HALLEY ENGINEERING CONTRACTORS, INC.

Project Name: Turnpike Widen HEFT from SR 836 to NW 106th Street

Subject: Critical Temporary Sheet Pile Walls

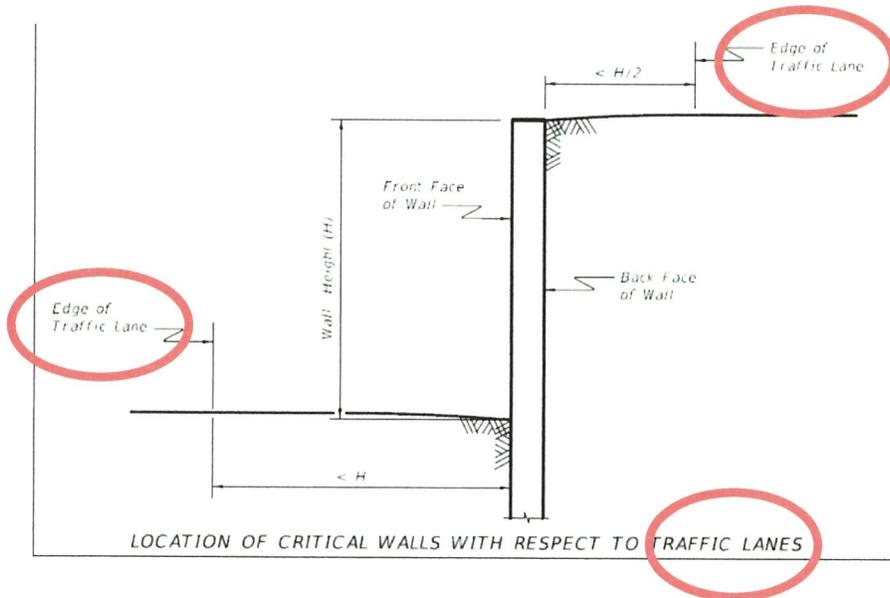
If the determination of the "edge of travel lane" wasn't confusing enough, the Department manages to confuse matters further. Let's take a better look at the authority that the Department cites to "define" its criteria, namely Figure 19.7-1 of the SDM:

Figure 19.7-1 fails to define, much less even reference “the edge of travel lane.” Rather, Figure 19.7-1 includes a new term: “Edge of Traffic Lane.” “Edge of Traffic Lane” and “edge of travel lane” are different terms. The Department has now cited two entirely different terms to demarcate the point from which “critical” wall determinations are made. This is an innate and indisputable ambiguity.

Further, once more the following questions are raised where the Department fails to define the term “Edge of Traffic Lane” within the four corners of the Contract. Is the Edge of Traffic Lane the point that vehicles would be presumed to reach (the point that temporary barrier wall is anticipated to be displaced)? Does the Edge of Traffic Lane include a shoulder where traffic is anticipated, especially on the Turnpike in evacuation route scenarios? Is the edge of Traffic Lane the outermost traffic stripe?

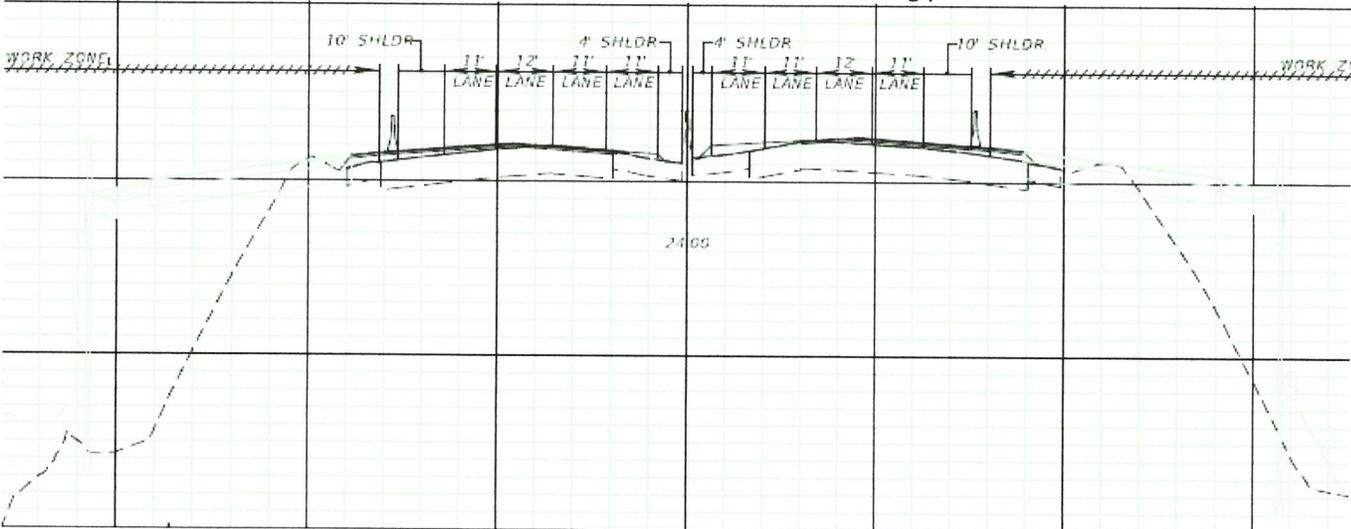
Applying the definition that a critical temporary wall is necessary to maintain the safety of the traveling public, or structural integrity of nearby structures or utilities during the construction, it is Halley Engineering’s position that temporary sheet pile at 25th St (B9RW-1,2,3,4), 41st St (B11RW-1,1B,2) and 58th St (B13RW-1,2,3,4) require “critical” temporary sheet pile.

In order to evaluate the safety of the traveling public, one must understand the Traffic Control Plans and define the limits of the traveling public. During this phase of construction, temporary asphalt will be placed on the median shoulder and traffic will be pushed to the inside while permanent construction is underway on the outside. As shown below, Halley Engineering will typically maintain a 4’ shoulder in the median, 4 lanes, a 10’ shoulder and a standard 2’ deflection zone behind the Temporary Concrete Barrier Wall. This area is clearly shown as the “limits of the traveling public.”

Where is the “edge of travel lane” in relation to this typical section? Where is the “Edge of Traffic Lane” in relation to this typical section? There is no clear answer within the four corners of the Contract.

As defined in the *FDOT Standard Specifications for Road and Bridge Construction*, “vehicular traffic areas are defined as those subject to vehicles within the traveled way, shoulders and auxiliary lanes.” The Specifications also require the 2’ deflection zone behind Temporary Concrete Barrier Wall for the safety of the traveling public. These specifications give emphasis to the limits shown in the above cross section, and therefore, are critical in evaluating the impacts on the traveling public.

The entire “traffic area,” including travel lanes, shoulder, barrier wall and deflection space would need to be able to be fully supported by the embankment slope in order for the temporary sheet pile wall to be considered “non-critical.” Simply put, if the temporary sheet pile wall was to fail, would there be a potential safety concern to the traffic above? HEC’s interpretation of the plan sections, based on the “traffic area” being the same point as the “edge of traffic lane,” results in a finding that areas exist where the embankment slopes of 2V:1H intersect with the MSE wall footprint when measured from the

2-foot deflection point from the back of temporary concrete barrier wall. When the slope intersects the proposed excavation area in this fashion, this condition is defined in the Specifications as requiring **critical temporary sheet pile walls** (supported by Figure 19.7-1 of the SDM).
